**UNITED STATES DEPARTMENT OF COMMERCE
Patent and Trademark Office**

09/314,001 05/19/99 ASLANOVA

OFFICE ACTION SUMMARY

☒ This action is FINAL.

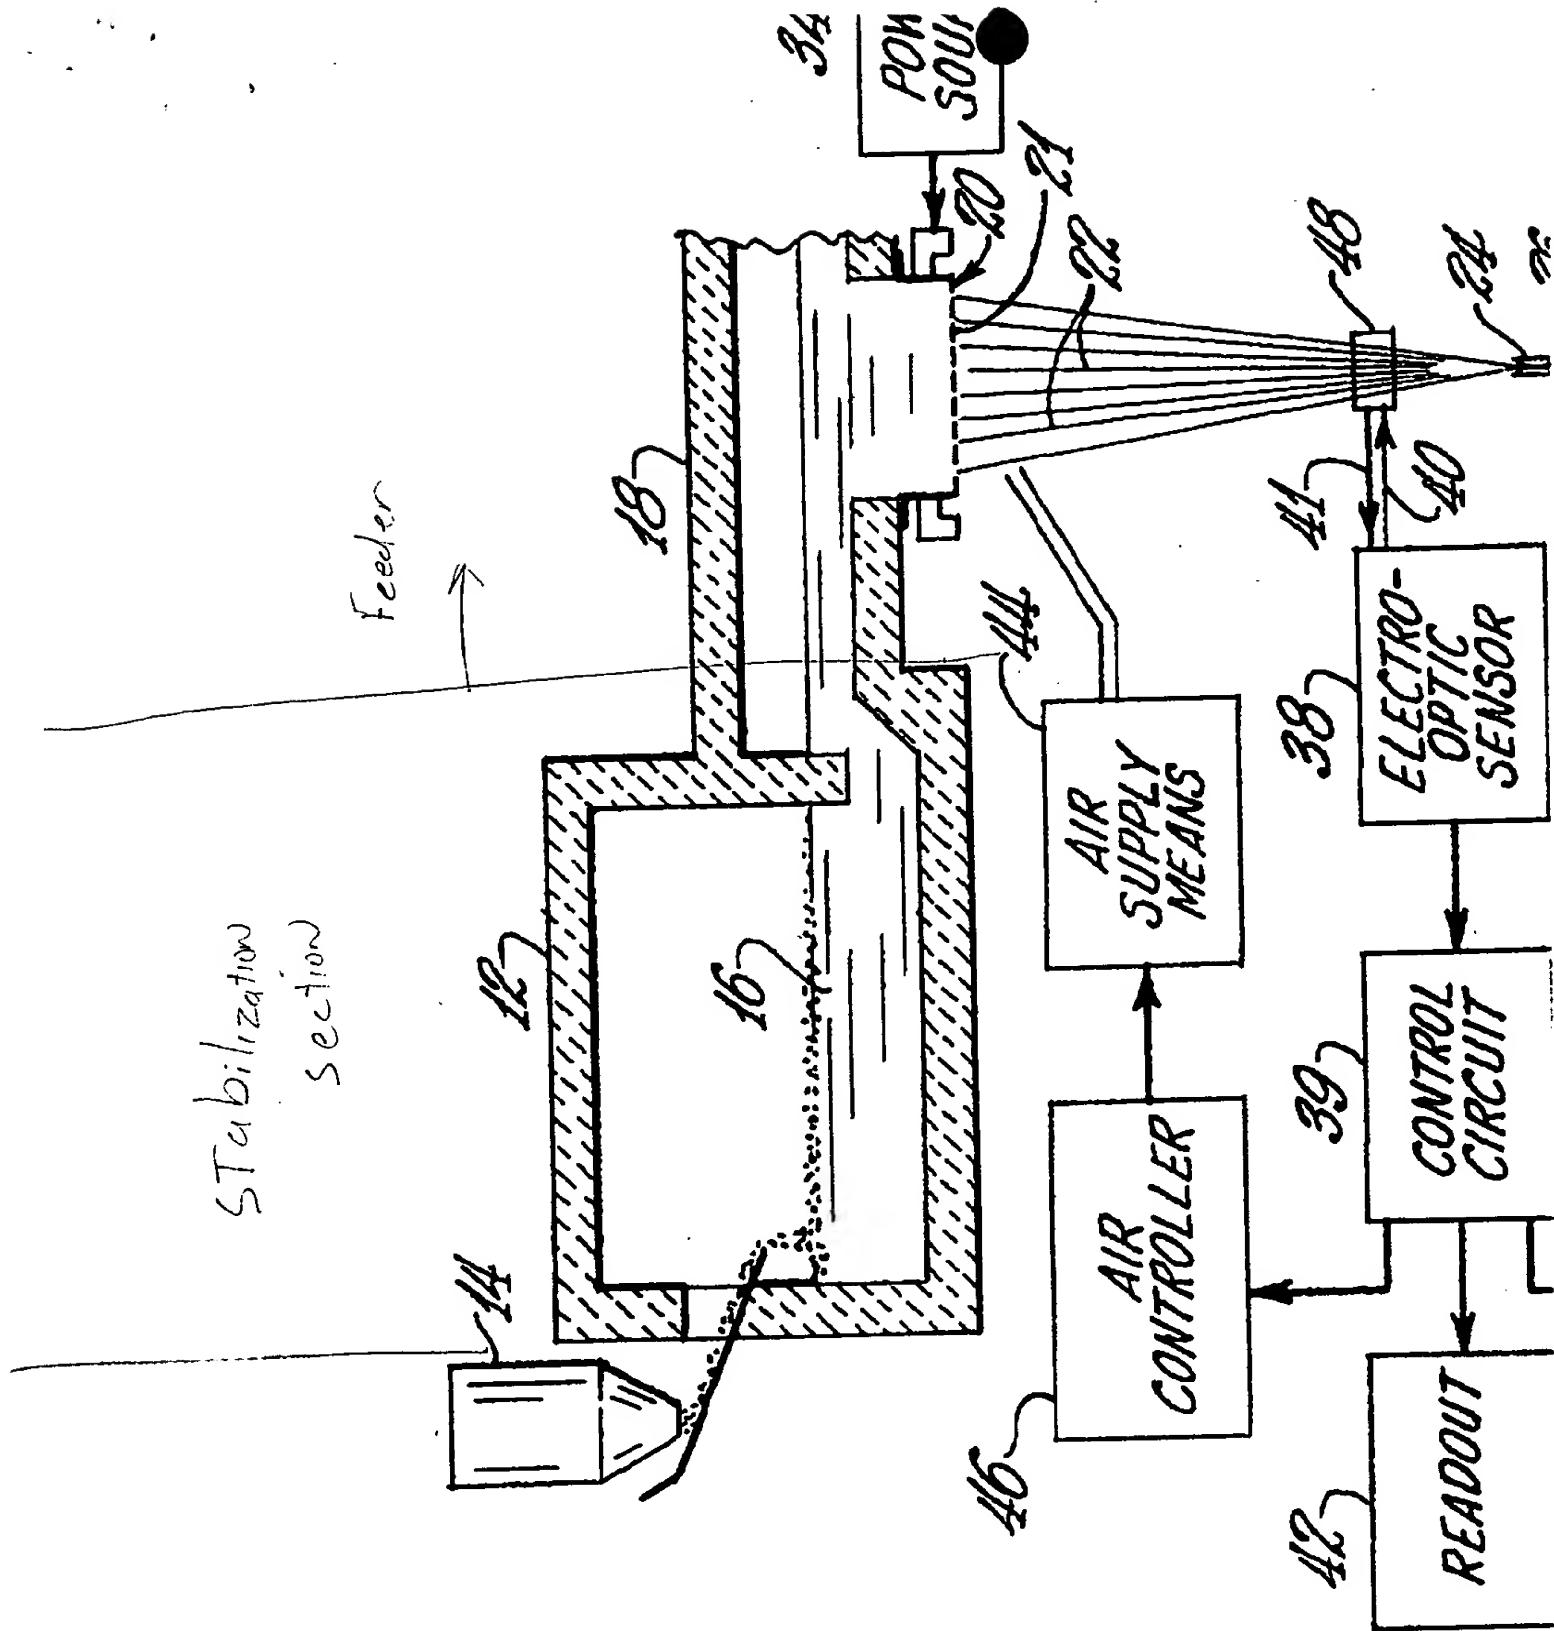
advantages that Shofner discusses. Looking at the attached enlarged Shofner figure. It is clear from the drawing that the glass obtains an even and smooth surface within the stabilization section. It is inherent that the glass temperature and viscosity is stable enough to make the fiber. Thus, the glass is deemed to be stabilized in volume in that it meets Applicant's description at page 4, line 34-26.

As to the second stabilizing: in the Shofner feeder the glass would still be homogenizing - thus it isn't stable - it's still changing. Alternatively, since the glass constituents are flowing it is unstable from a kinetic energy standpoint. They are stabilizing further.

It is argued that invention is allowable because the melt becomes stable in volume because gas bubbles and foam are expelled. The claims do not require this: there is no explicit requirement in the claims; page 5, line 1 and page 4 lines (21-24) states that such is merely "possible"; and it is clear from the drawing that there is no foam in the stabilizing section 16.

It is further argued that the glass is kept in the stabilization section until it reaches the fiber manufacturing temperature. This is an extremely broad limitation - there is no definition for this term. This temperature could be the temperature of the fibers as drawn, the temperature of the flames of attenuation burners, the temperature of the fibers as they are being coated - in fact it could relate to the temperature of some other fiber making process. It is clear that whatever temperature the combination of reference would have, that there is some temperature in a fiber manufacturing process that is equal to it. In fact, since the Shofner temperature is equal to itself,

and since it is glass used in a fiber manufacturing process, it is "a fiber manufacturing temperature."
